Mesa Public Library Noise Issues

Issues

Level 2 Meeting Rooms

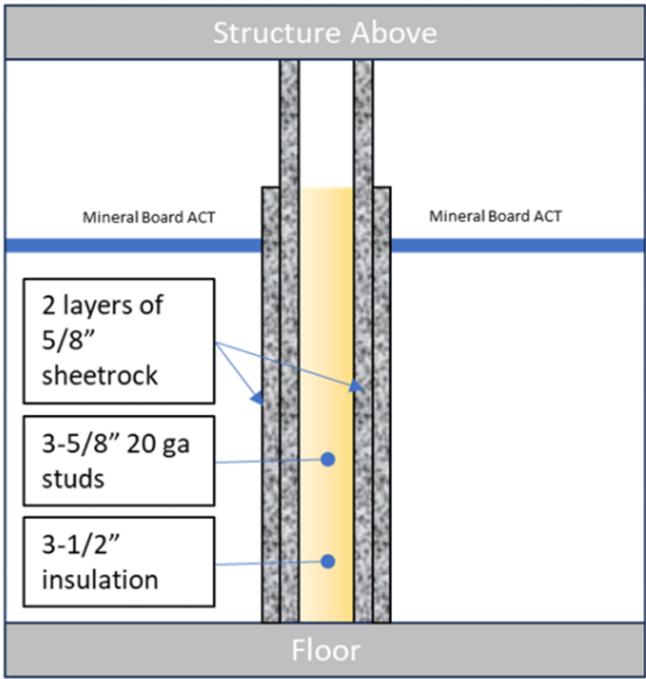
- Sound transmission between adjacent rooms when the operable partition are in use is poor.
- Speech intelligibility between meeting rooms relates to both the audibility of the intruding sound and the intelligibility of the speech itself.
- Eliminating the sound transfer entirely is not feasible with an operable wall.
- Over time the seals on the operable walls can become misaligned or degrade and no longer seal.

- It is recommended that the library contacts its local folding partition vendor (Modernfold is installed) to perform a maintenance inspection and to verify the integrity of the seals and wall panels.

- If this evaluation does not yield any noticeable improvements the we recommend that the replacement of the existing partitions be considered.
- If replacement is the path forward, a newer option providing a higher level of sound isolation can be selected.

- We recommend that a partition with an STC-53 or better be selected.
 - This can be the Moderco Signature 800 or the Modernfold Encore
 - It should be noted that although operable partitions can be rated above an STC-50 they often perform 5-7 point lower than their STC rating once installed, due to various in-field conditions.

- The alternative is to replace the folding partitions with a fixed wall assembly. Although this would eliminate the flexibility of the space, the STC-55 assembly will achieve a superior level of acoustic noise reduction as compared to an operable wall.

Level 1 – Group SC Room & Small Study/Phone Rooms

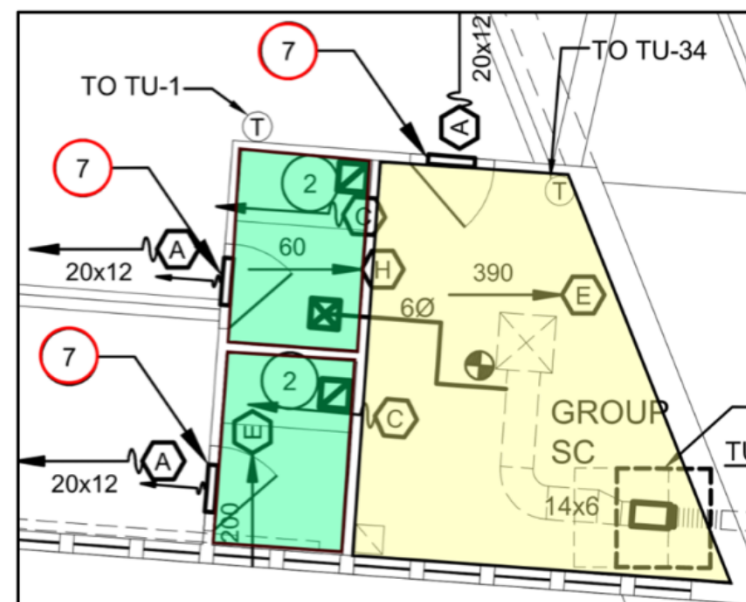
- **Group SC Room:** Elevated temperatures have occurred in this room prompting an increase in airflow to improve cooling. However, the added air volume is resulting in higher background noise levels in the room.

- **Inter-room Noise Transfer:** Sound is transferring between adjacent rooms. This occurs through 2 primary paths.
 1. Directly through the wall structure, which is dependent upon the performance of the assembly. (STC rating)

2. Indirectly through the ceilings, where sound travel through the ceiling, over the top of the wall, and then enters the adjacent space through the ceiling of the neighboring room. (CAC rating)

- **Noise Leakage to Public Areas:** Sound from the enclosed rooms is also escaping into adjacent public spaces via the return air openings located in the walls. These openings are shown as red circled “7” in the layout. The return air openings are located within the walls or doors below the room’s ceiling plane.

Level 1 – Lisa Rivera's Offices

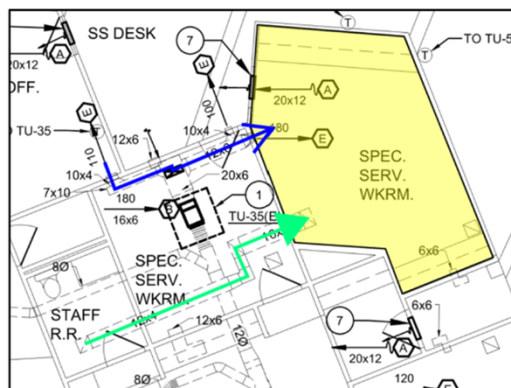
- This office features an open ceiling design with exposed wood framing.
- **Loading dock door noise:** A squeaking sound is consistently heard from the operation of the loading dock door located directly beneath the office.

- **Airborne Sound Transmission:** Noise is also transferring into and out of the office through the wall mounted return air opening.

- It is suggested that WD-40 or similar be applied to the loading dock door hinges.
- **Intermittent Loud Disturbances:** On occasion, loud noises resembling someone screaming have been heard. Most likely this is occurring through the duct path that is connected to adjacent rooms, such as Staff Restrooms or the OC Office.

- It is suggested that a 5-foot section of duct connecting the office to the restroom and the OC Office be internally lined with fiberglass ductliner. Alternatively, this section of duct can be replaced with 5-foot-long insulated flex duct.

Level 1 Mitigation Options – Noise Transmission Between Rooms

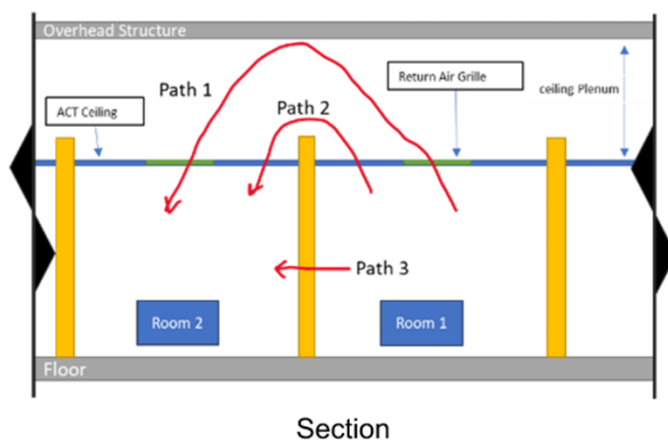
- Existing walls in most rooms were determined to be constructed using 1 layer of sheetrock on each side of 3-5/8" metal studs with no insulation in the stud cavity. This wall performs around an STC-35 to STC-40.
- Walls are partial height and stop above the ceiling.
- The ceilings appear to be a mineral board ceiling tile which performs around a CAC-30 to CAC-35.
- With the open return grilles in the ceiling located close to one another, the performance through the ceiling is expected to be reduced. Therefore, the combined architectural separation between rooms is expected to be around an STC-35.

- Path1:** Through the return air opening into the ceiling plenum and back down through the return air opening into Room 2
- Path2:** through the ACT tile into the ceiling plenum and back down through the ACT tile into Room 2
- Path3:** through the body of the wall

Level 1 – Operations Librarian Office

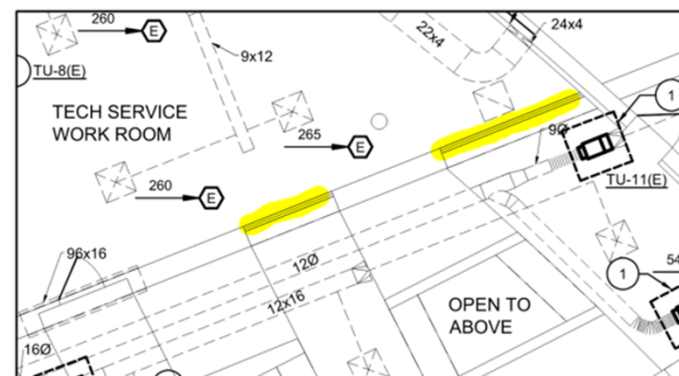
- Although this Level 1 office is currently vacant, the reported noise issues involves conversation within the space being audible in the adjacent public areas.
- Sound is easily passing through the single-pane wall mounted window.
- This window is now permanently sealed.
- Staff in the workroom can hear kids from the Children Collection Area through the single pane windows, highlighted in yellow.

- If the window is no longer needed, remove it and fill in the opening to match the wall's constructed assembly.
- If the window is still needed, replace it with a double pane window consisting of 1/4" glass_1/2" airspace_1/4" glass
 - This glazing assembly is expected to improve sound isolation by approximately 10 dB compared to the existing glass, effectively reducing the noise transmission by half.

Ground Level – Young Adult Reading Area

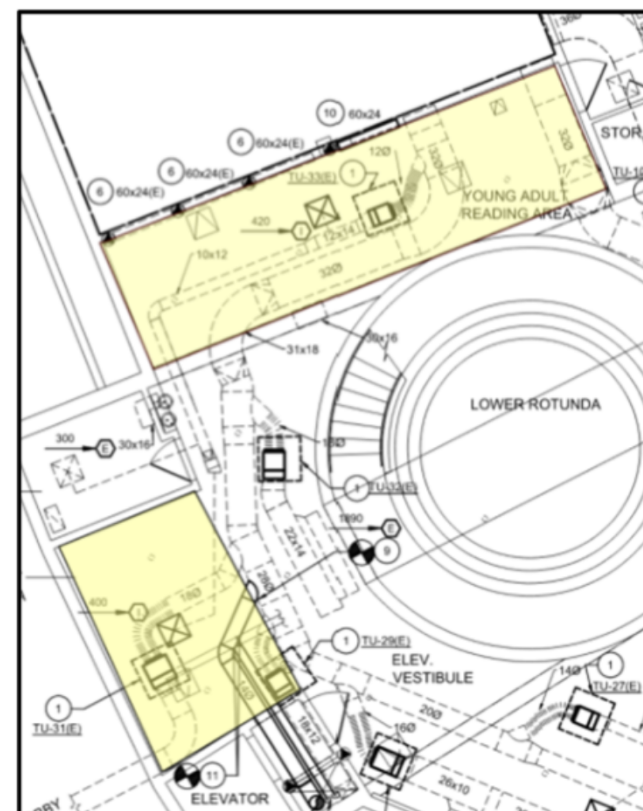
- Elevated background noise levels are present within the areas shown in yellow.
- This appears to be due to excessive airflow. When standing in these locations, one can feel a strong air current and observe nearby decoctions visibly moving, indicating high velocity air movement in the space.

- The background noise levels was measured to be 59 dBA (NC-52) which is substantially above the recommended background noise level of library reading zones of 35 dBA (NC-30).

- The Test & Balance Report dated February 25, 2019 was reviewed as part of this investigation and was assumed to be the final version.
- However, upon examination, several items listed on pages 8-10 remain unresolved. These include:

- Terminal units TU-33 and TU-31, located above the Reading Area per plans, are reported as balanced to maximum airflow rates of 1120 cfm and 2195 cfm respectively.

- But based on the pronounced airflow and movement of hanging elements in this area, it is likely that the actual airflow and associated airflow velocities in these zones are exceeding the reported values.

- It is also conceivable that the air reaching the Group SC Room on Level 1 is impacted by the amount of air being lost over the Youn Adult Reading Area, resulting in less air available to cool this room and possibly other rooms in the library.

Sound Travel through the Rotunda

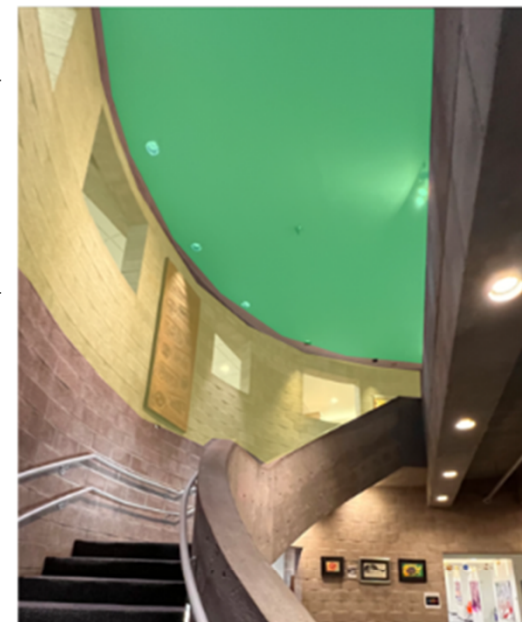
- Children's events are internally scheduled outside of regular business hours to minimize the noise impact on library patrons.
- The event was clearly audible through the rotunda during our visit and into the surrounding areas on all three floors indicating significant vertical and lateral sound transmission

- A noise test was conducted while onsite using a speaker positioned on the ground floor of the rotunda and set to generate white noise. This test was used to evaluate how sound attenuates as it travels vertically through the rotunda.

- Sound levels were measured on the ground floor, Level 1, and Level 2.
- RESULTS:
 - 6 dB reduction in noise between the ground floor and Level 1
 - 25 dB reduction in noise between the ground floor and Level 2

- This is consistent with our observations as the rotunda is more acoustically open between the ground floor and Level 1 as compared to the single door connecting Level 2.

Wall Openings – Mitigation Option 1

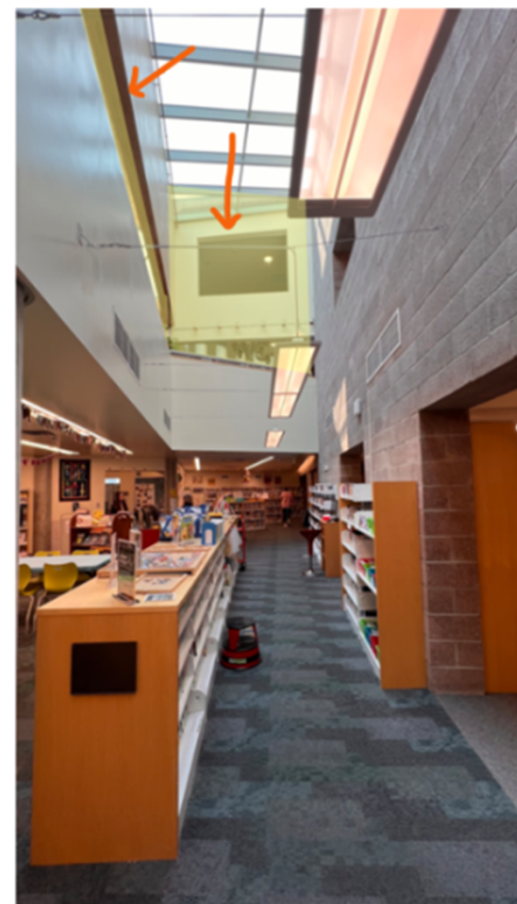
- Multiple openings in the circular walls of the rotunda permit sound to travel into adjacent areas of the library
- Blocking these opening with glass will substantially reduce noise transfer from the rotunda to surrounding spaces.
- The closure of these openings must be carefully coordinated with the building's HVAC airflow dynamics and fire/smoke evaluation requirements to ensure compliance with safety standards and to maintain proper ventilation.
- If closure of the openings is possible, the glass should be 3/8" thick.

- Noise transmission between the ground level and the reference desk, as well as sound intrusion at the circulation desk is an ongoing issue that affects both staff and patrons.
- These areas are acoustically linked due to their architectural connectivity.
- To achieve meaningful noise reduction, a physical separation between these spaces would be needed.
 - One solution is to install glass walls at the Level 1 openings overlooking the ground floor.
 - Again, these closures must be carefully coordinated with the building's HVAC airflow dynamics and fire/smoke evaluation requirements to ensure compliance with safety standards and to maintain proper ventilation. There is also the possibility of it contributing to solar heat gain from the skylight above.
